Project Name: Comfort Care White Lake
 Description: Rezoning & Preliminary Site Plan Approval
 Date on Agenda this packet pertains to: January 20th, 2022

RE: Comfort Care Assisted Living- Preliminary Site Plan Review – 2nd Review

RE: Comfort Care
Rezoning and Preliminary Site Plan – Review #2

PARKING STALL PAINT STRIPING DETAIL
NO SCALE

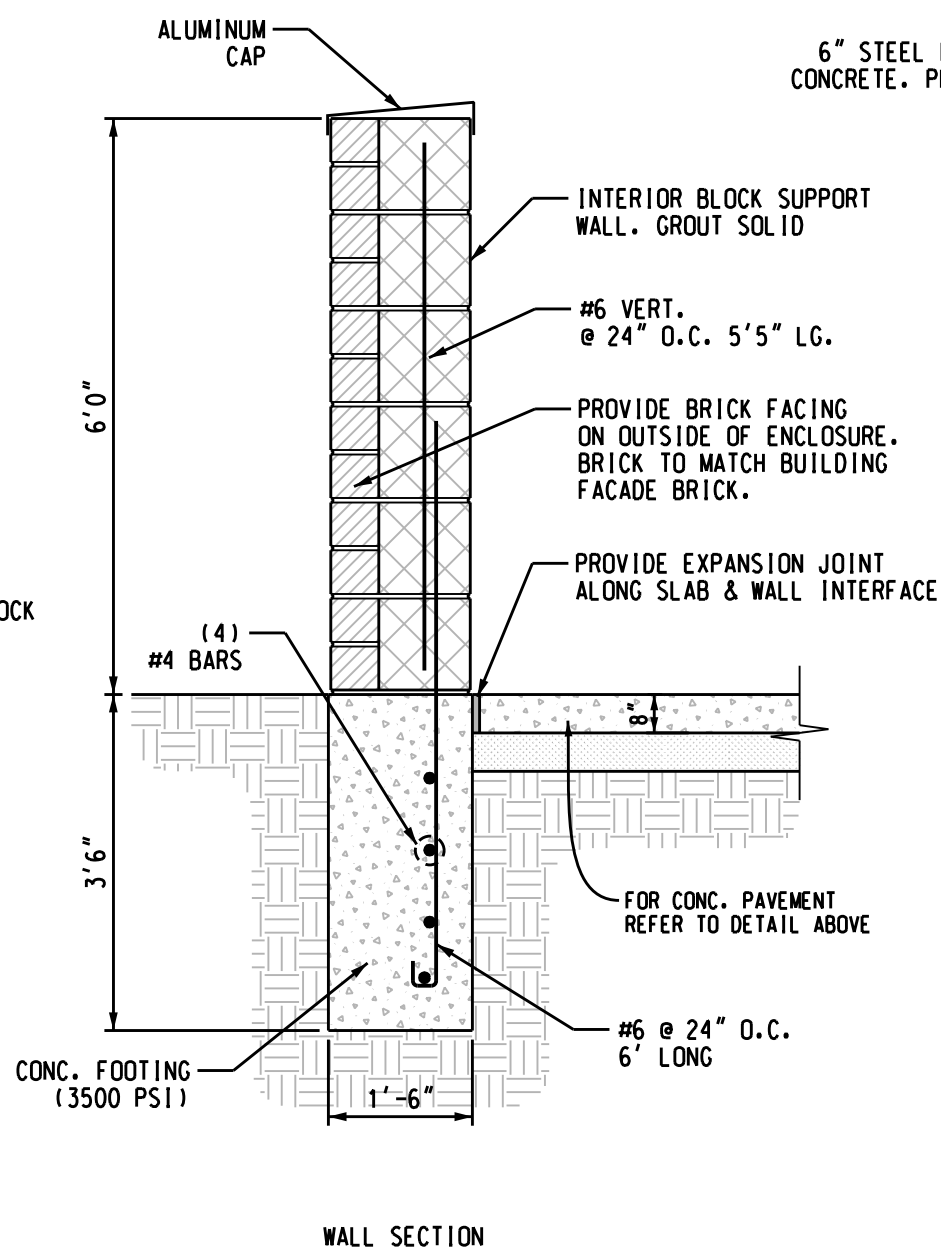
The zoning ordinance requires each individual parking space be delineated by dual stripes, two feet apart centered on the dividing lines and painted white. The site plan shall be revised accordingly to indicate the required striping. A “Van Accessible” sign detail for the barrier-free parking shall also be provided on Sheet C600 of the site plan. (Comment addressed. Paint striping was revised to dual striping as required, and the ‘Van Accessible’ sign detail is now shown on Sheet C600).

TRASH ENCLOSURE DETAIL
NO SCALE

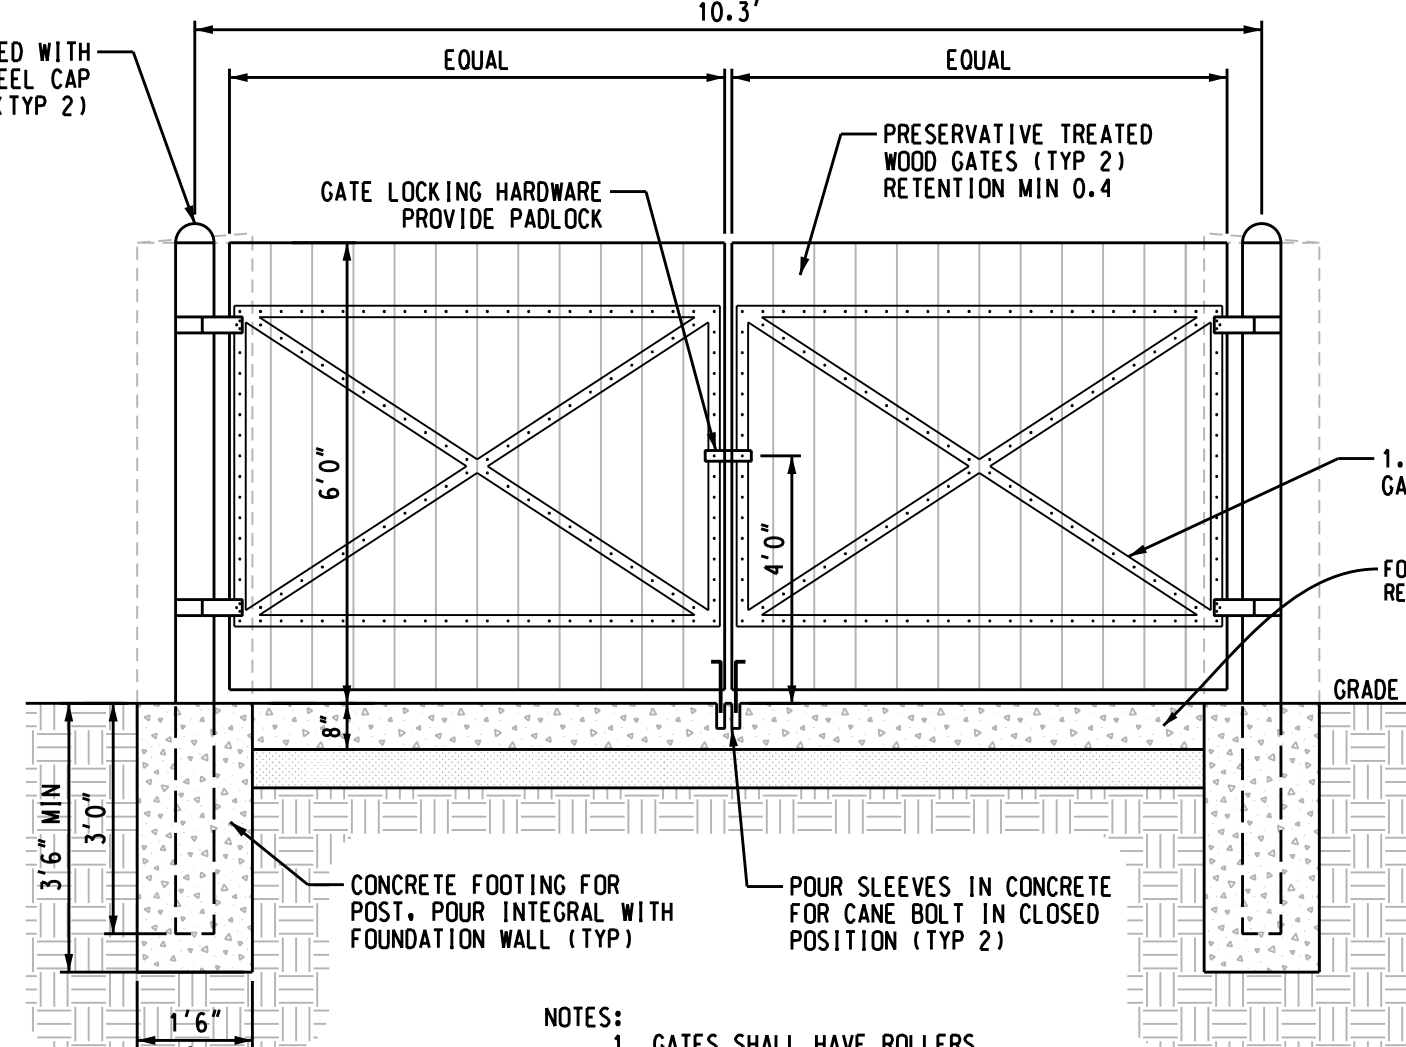
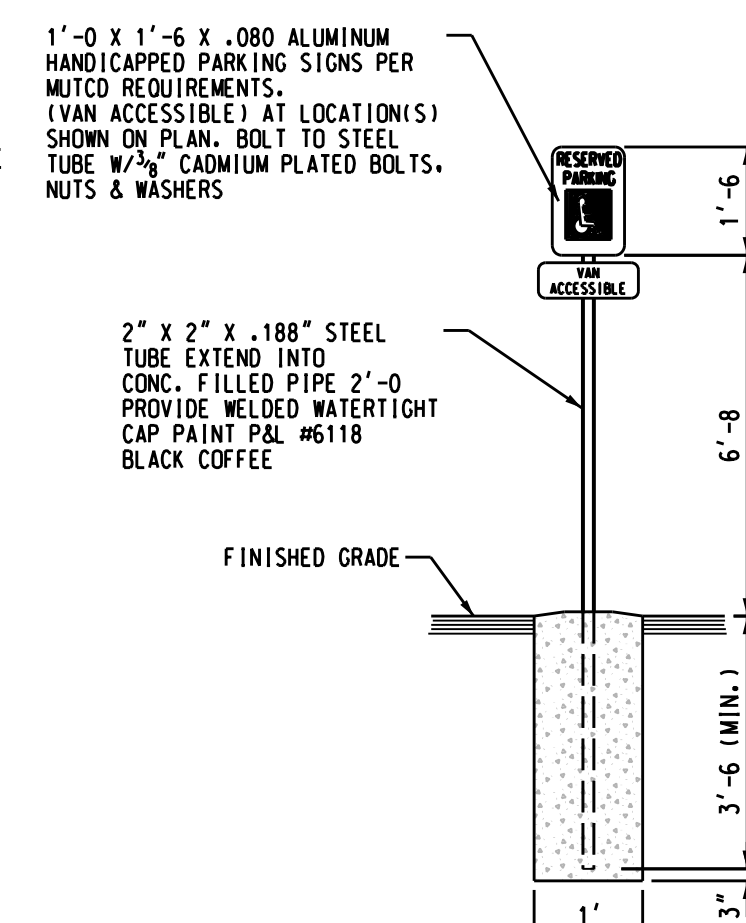
The zoning ordinance requires dumpsters to be surrounded by a six-foot-tall wall on three sides and an obscuring wood gate on a steel frame on the fourth side, located on a six-inch concrete pad extending 10 feet in front of the gate, with six-inch concrete-filled steel bollards to protect the rear wall and gates. **As proposed, the pad does not satisfy zoning ordinance standards. The depth of the pad shall be clarified on the Sheet C600. A six-foot concrete apron is proposed; therefore, a four-foot waiver is requested.** (Comment partially addressed. The plans were revised to extend the concrete apron to 10 feet as required. The depth of the pad shall be indicated on the trash enclosure detail). The proposed enclosure is located west of the building. A six-foot-tall block (8-inch) wall is proposed around three sides of the dumpster enclosure, with a steel backed wood gate on the northeast side of the structure. The zoning ordinance states dumpsters and trash storage enclosures shall be constructed of the same decorative masonry materials as the buildings to which they are accessory. Brickform concrete (simulated brick pattern) or stained, decorative CMU block are not permitted where the principal building contains masonry. Plain CMU block is also prohibited. **As a condition of site plan approval, the dumpster enclosure shall match the same brick veneer as the facade of the building with a steel backed wood gate painted a complementary color to the brick veneer. The trash enclosure detail on Sheet C600 of the site plan shall be revised to show a brick face on the outside walls of the enclosure and indicate the color of the gate.** (Comment addressed. The facade of the dumpster enclosure was revised to match the building facade (brick veneer).
